PCN – Process Change Notification

Change:	AP.35A.07.0054A
Date:	2017/04/27
Author	Haley Tsai

Model#	Part Number	Changes
AP.35A - 1 Stage 15dB-54mm 1.13 IPEX MHFI - Back End SAW Filter	AP.35A.07.0054A	Amend Dimensions

Illustration of Change

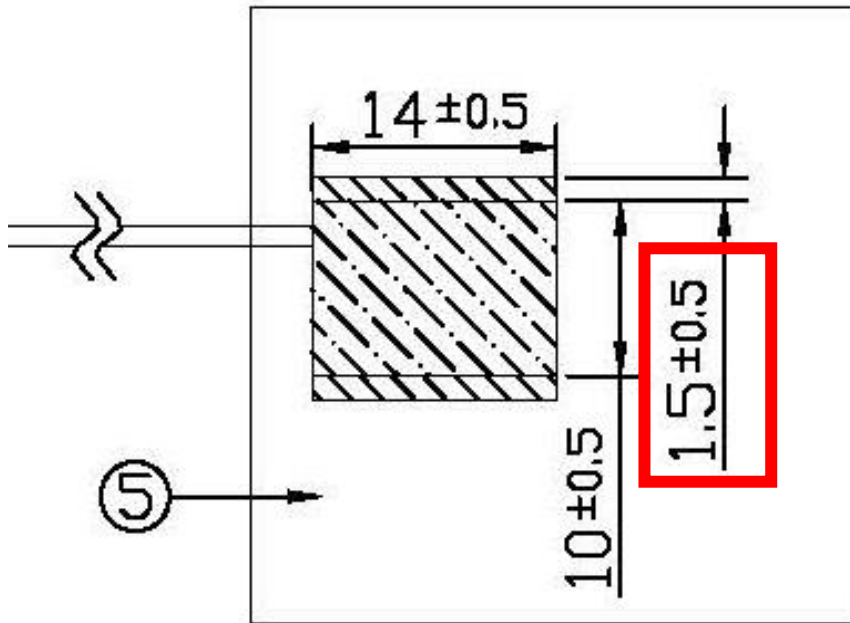
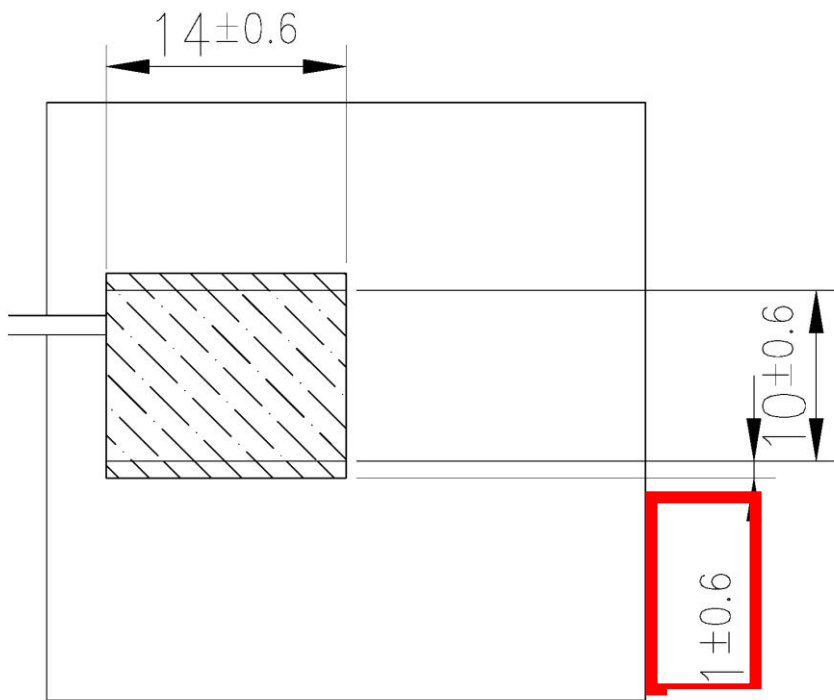
- Amend Dimensions

Old drawing

Name	P/N	Material	Finish	QTY
1	AP.35A Patch (35*35*4mm)	001513B170007A	Ceramic	Clear	1

New drawing

Name	P/N	Material	Finish	QTY
1	AP.35A Patch (35*35*3.5mm)	001517C120000A	Ceramic	Clear	1
